Record of Executive Business and Chief Executive's Order

Reg. Reference: SD22A/0099 **Application Date:** 06-Apr-2022
Submission Type: New Application **Registration Date:** 06-Apr-2022

Location: Site at Calmount Road and Ballymount Avenue,
Ballymount Industrial Estate, Dublin 12

Figure 1: Medium to Long Term Road Proposal through application site – South Dublin County Council Development Plan 2016 - 2022

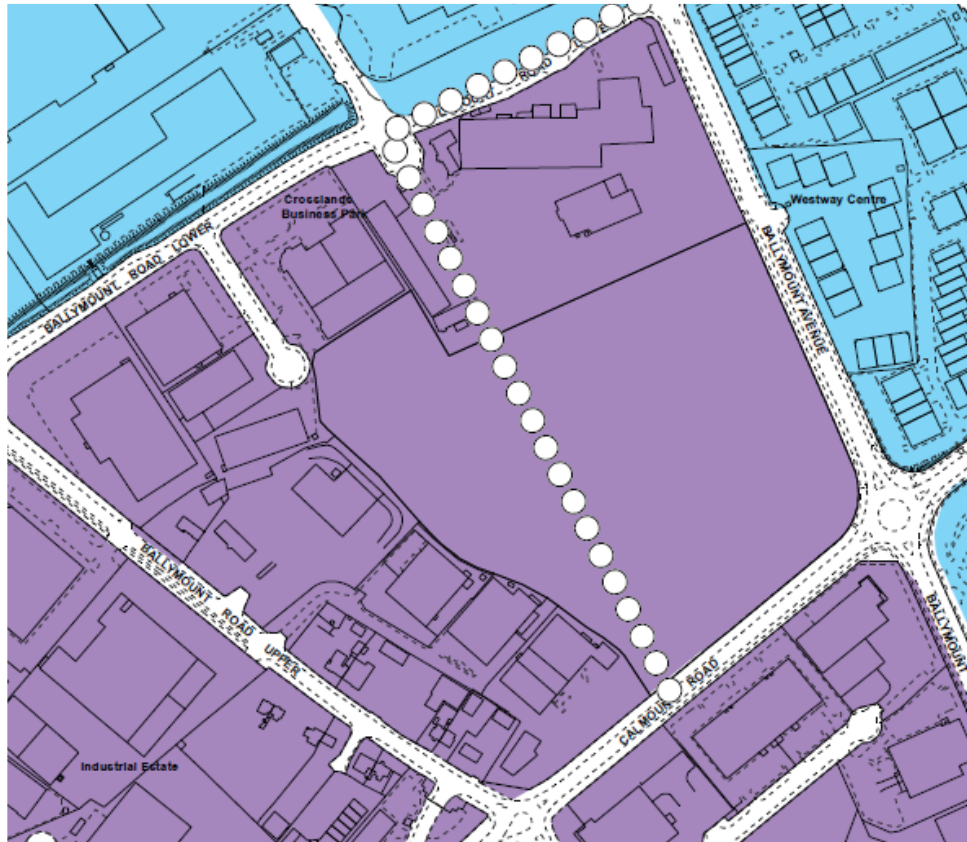
The entire of application site is traversed between its northern and southern boundaries by a Road Proposal (Long Term) as identified on Map 5 (see figure 1 below) and Table 6.6 (Medium to Long Term Road Objectives) of the South Dublin County Council Development Plan (2016 – 2022), as follows:

Furthermore, the appropriate hierarchical positioning, width(s), alignment, and connection point with Ballymount Road Lower for the County Development Plan Roads Objective to which the subject through road proposal relates, is yet to be fully investigated and determined by the planning authority.

Figure 2: 6 Year Road Proposal along Northern Boundary of Site – Draft South Dublin County Council Development Plan 2022 – 2028 (July 2019)

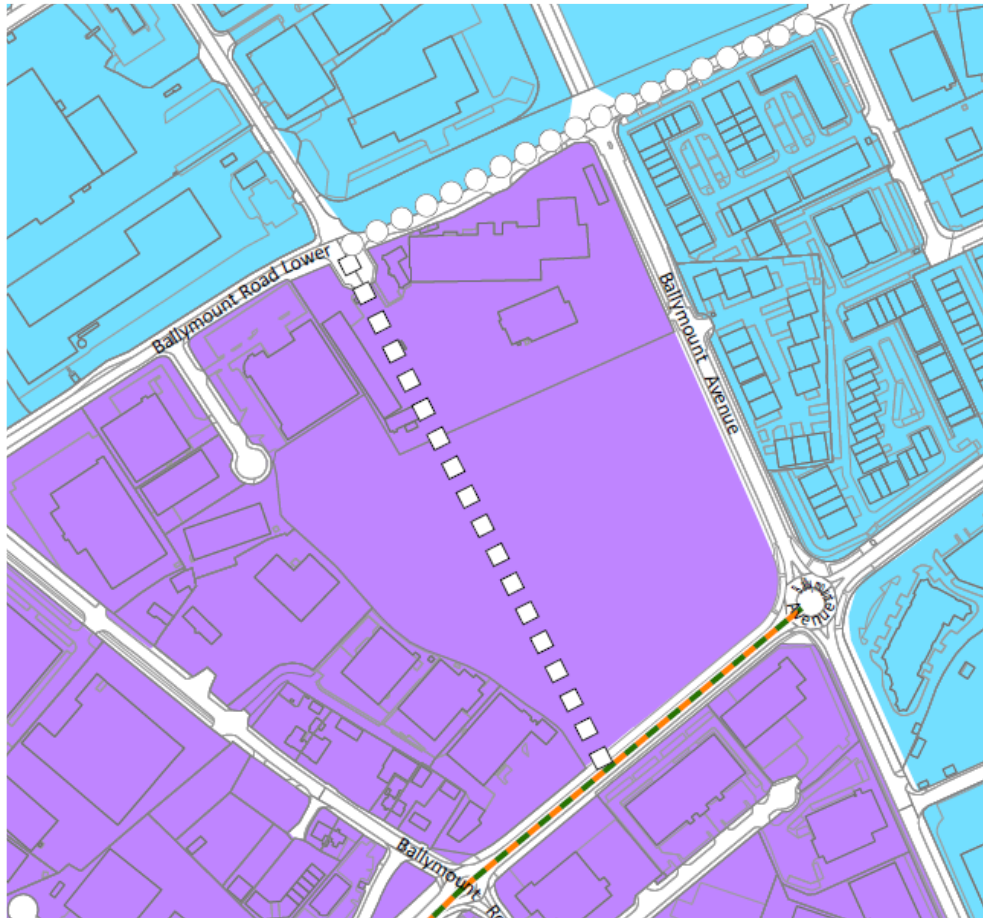
The Planning Delivery Team advise that the subject Roads Objective is of potential importance from the perspective of helping to create a permeable network of streets and urban blocks that links Calmount Road with Ballymount Road Lower while aligning with the Merrywell Industrial Estate Road to the north of the application site.

The development proposal responds to this road's objective through the incorporation of a road proposal through the application site, which the applicant suggests will be taken in charge by the local authority. The proposed road would be accessed via a splayed entrance off Calmount Road at the southern boundary of the application site and would terminate at its northern boundary in the form of a "mini round about".

Figure 5: Extract of Applicant's Road Layout Proposal at south-eastern corner of site

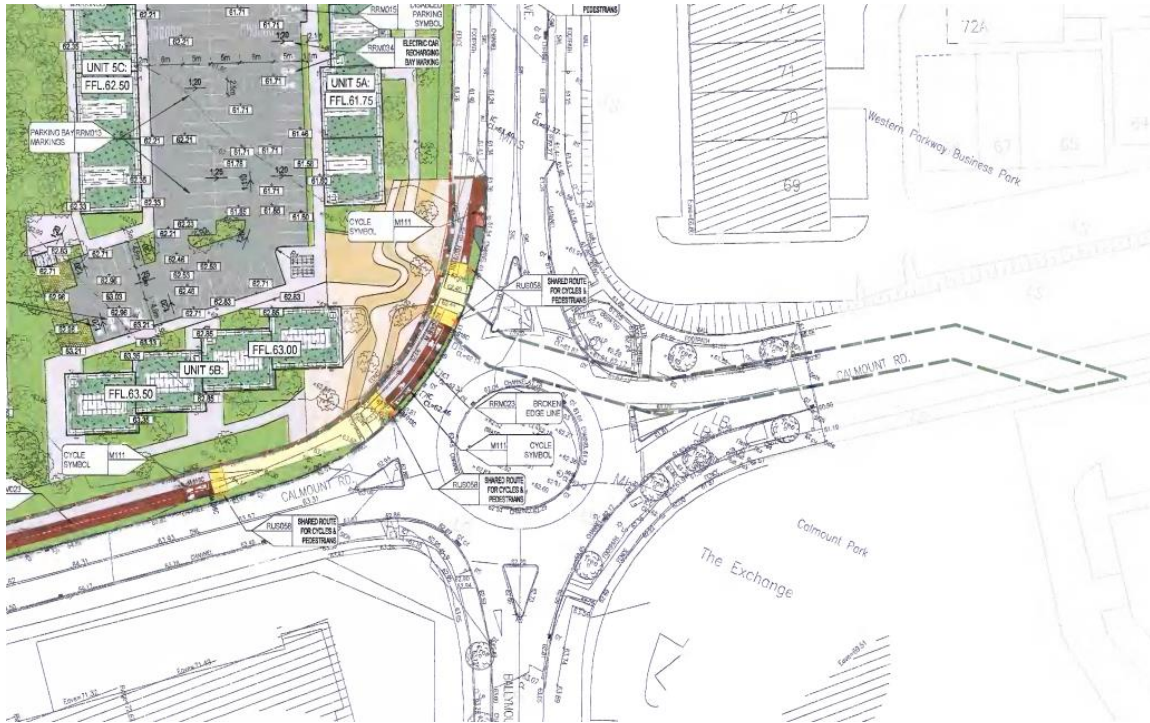
The TTA and an “Off Site Road Layout” that is submitted with the subject application acknowledges the NTA’s Preferred Route but does not detail how the proposed development would tie in with it. The Road Layout Plan submitted with the subject application is based on the existing roundabout junction and proposes the inclusion of a new footpath and off-road two-way cycle track along the Southern/Calmount Road boundary of the application site¹ to tie in with a new shared surface/tactile paved area proposed by the applicants at the existing unsignalised crossing on the north-western side of the roundabout junction. This would in turn tie in with a landscaped entrance plaza proposed at the south-east corner of the application site as well as a further proposed section of two-way cycle track.

There is potential conflict, however, between sections of the applicant's proposed pedestrian, cycling, crossing and plaza entrance facilities at the south-east corner of the application site and the western arm of a converted roundabout junction that the NTA have identified as a part of their Emerging Preferred Route for the Core Bus Corridor.

- *The width of streets, footways, verges etc.*
- *The location, type and configuration of crossings and junctions.*
- *Kerb lines (including heights)*
- *Surface Materials and Planting.*
- *Lighting*
- *Areas to be taken in charge and in public ownership.*

Figure 6: Extract NTA's Greater Dublin Area Cycle Network Plan (2013)

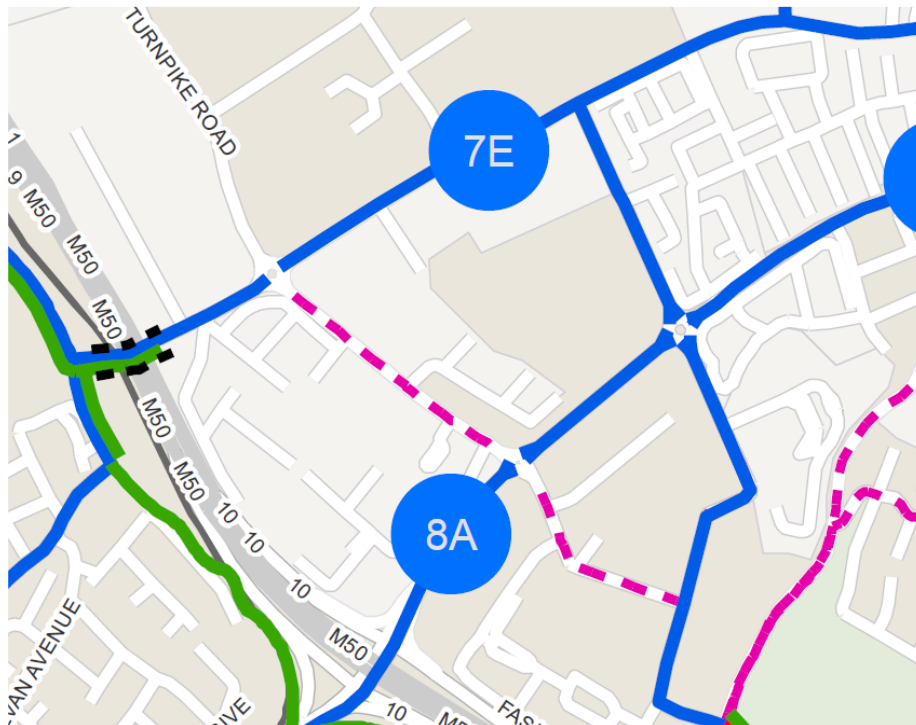
Secondary Cycle routes are planned along the southern/Calmount Road and eastern/Ballymount Avenue boundaries of the application site under the NTA's Greater Dublin Area Cycle Network Plan (2013). The route along Calmount Road (8A) would comprise a strategic secondary route between City West, Ballymount, Walkinstown, Crumlin and Dublin City Centre. The NTA's Draft Greater Dublin Area Cycle Network Plan (2021) proposes to replace this with a section of Primary Radial cycle route.

It is noted that an off-road cycle track and footpath already exists along the eastern/Ballymount of the site, however, no such facilities exist along southern/Calmount Road Boundary, which comprises a grass verge. The proposed development responds to this with the inclusion of a two-way off-road cycle track along the southern/Compound Road Boundary of the application site together with a footpath and planted verge to replace the grass verge. The proposed two-way cycle lane would continue around the southeast corner of the site and tie in with the existing single way cycle lane on Ballymount Avenue. The proposed cycle track coincides with a letter of consent and map from SDCC relating to a proposed watermain connection on Council Owned lands along the southern boundary of the site. A landscaping section indicated that the proposed two-way cycle track would measure 2.5 metres in width, which appears to comply with the NTA'S National Cycle Manual in terms of appropriate cycle lane/track widths.
